**OHIO DEPARTMENT OF TRANSPORTATION**  
CENTRAL OFFICE, 1980 W. BROAD ST., COLUMBUS, OHIO 43216-0899

Re: 2005 First Quarter Revisions

## Summary of First Quarter, 2005 Revisions to the ODOT BDM

Figure 328

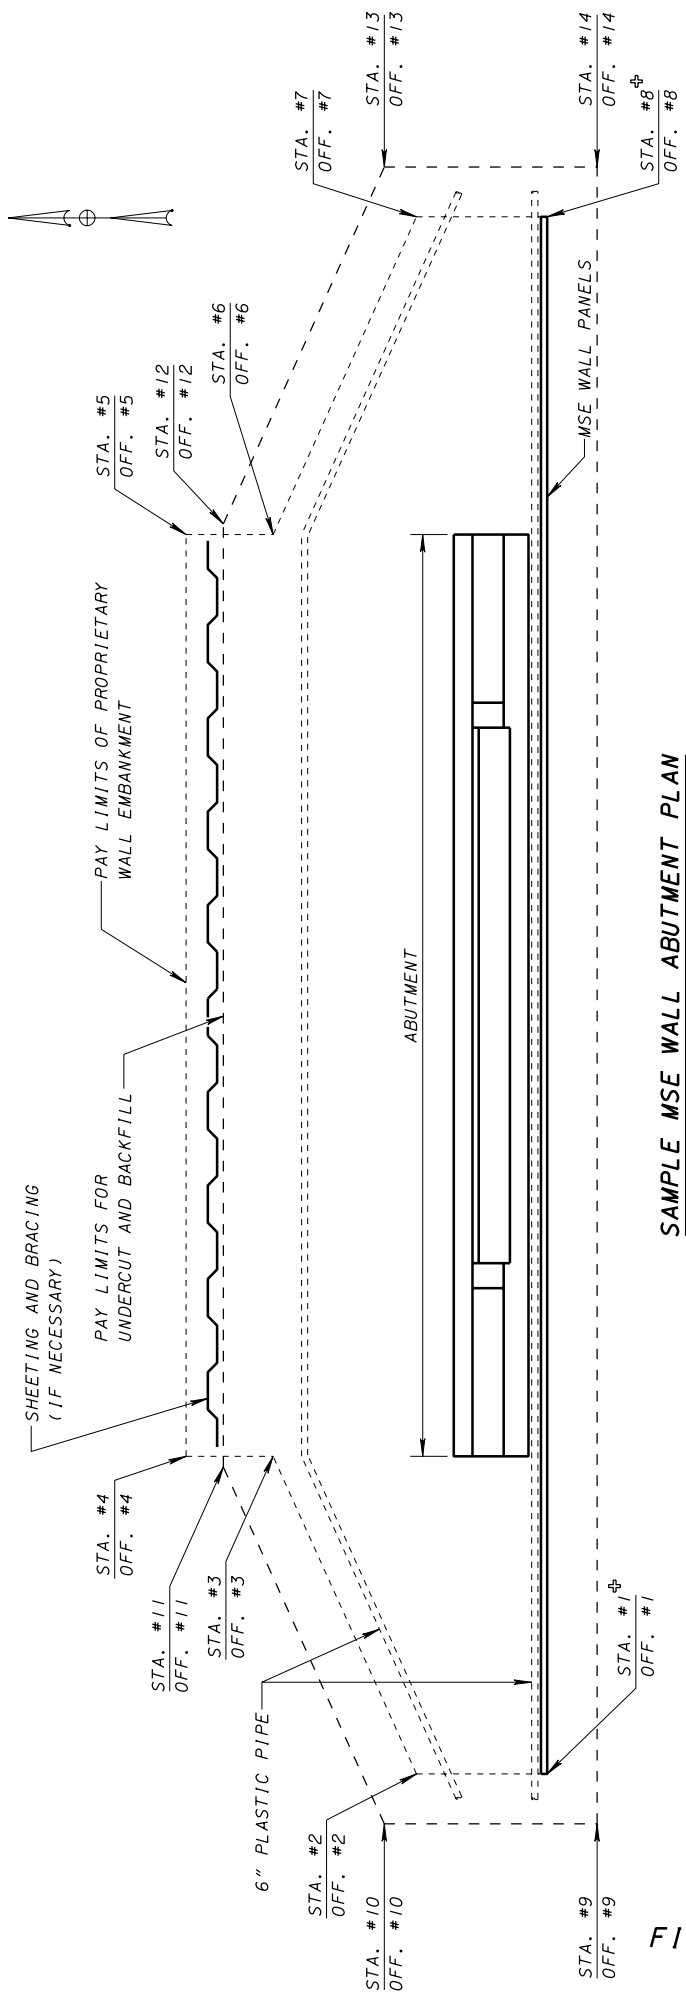
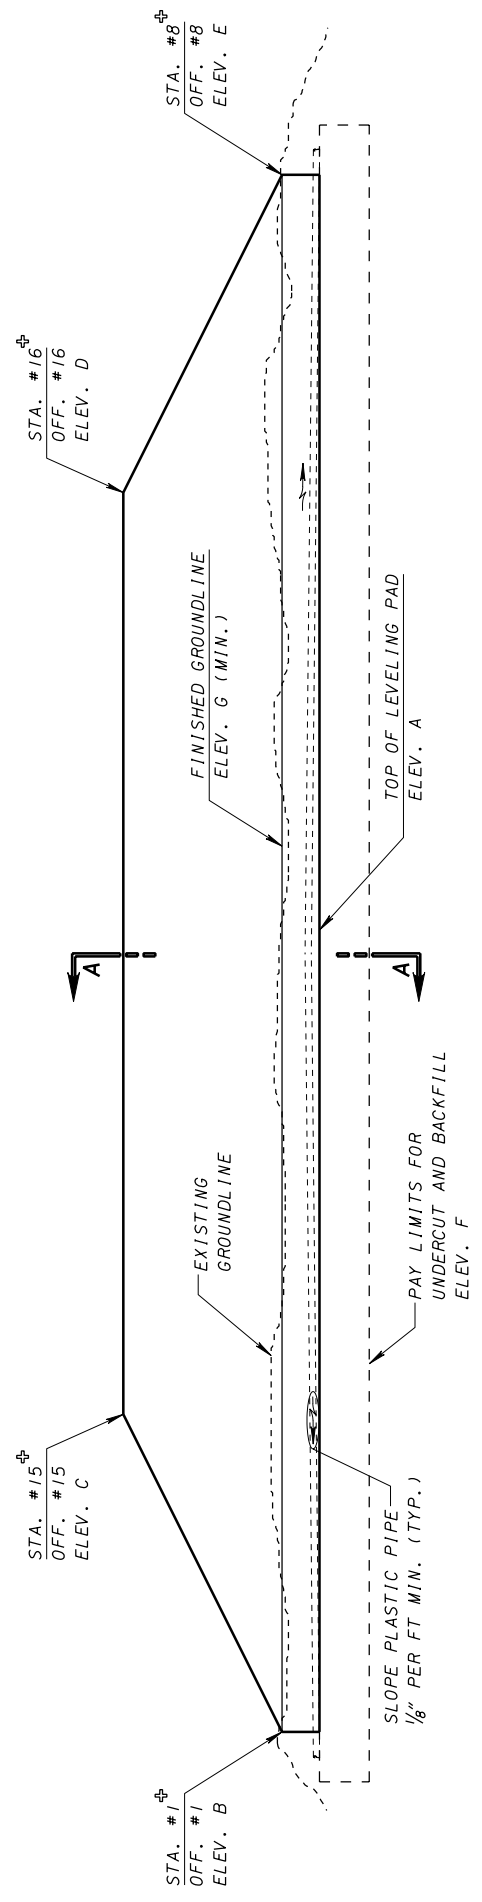
<b>BDM Section</b>	<b>Affected Pages</b>	<b>Revision Description</b>
303.5	3-76 through 3-81	This section was revised to provide the designer a better understanding of the detail design requirements for a proprietary retaining wall.
Fig. 329		This new figure details sample plan and elevation views of an MSE Wall supported abutment.
Fig. 330		This new figure details a cross section through an MSE Wall supported abutment with undercut and backfill requirements.
Fig. 331		This new figure details a cross section through an MSE Wall supported abutment with no undercut and backfill requirements.
Fig. 332		This new figure details an MSE wall supported abutment, MSE Wall backfill drainage and MSE wall coping.
Fig. 333		This new figure replaces Fig. 202 and details an MSE wall supporting a roadway embankment including a traffic barrier.
412/413	4-17 4-19 4-21	The section headings were renumbered to correct for a typographical error that occurred on page 4-17.

A. Plan View of the wall showing: (Refer to Figure 329)

B. Elevation of the wall showing: (Refer to Figure 329)
